Technical Bulletin T753

Product: A/V Receiver

Hardware Technical Bulletin: T753-H2005-06

Date: February 28/05 **Subject:** Intermittantly shuts down
Note: Implemented in production from serial number:R44T75307875

Figure 1

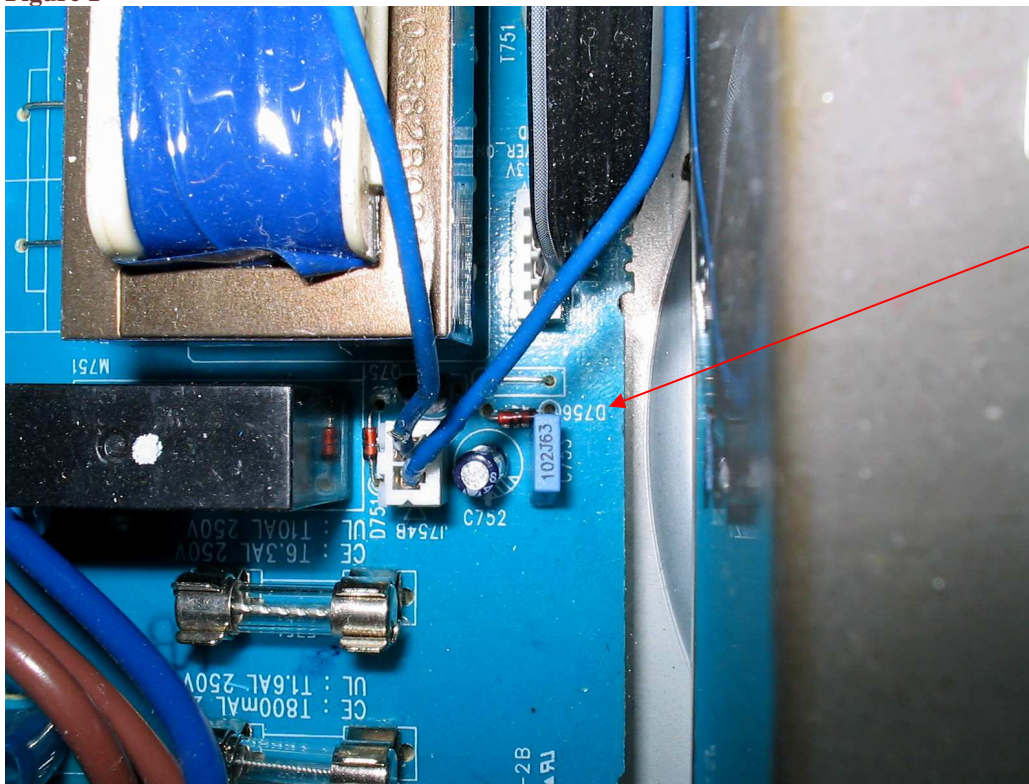
DESCRIPTION: Unit may shut down, shortly after turn on.

REASON: There is a diode on the standby board that maybe operating intermittantly.

**D756
CHANGE
FROM
1N4148 TO
1N4001**

SOLUTION: Locate and identify D756 on the standby board. Change only if the diode is a 1N4148. Change from a 1N4148 to a 1N4001 or equivalent. See figure 1 for details.
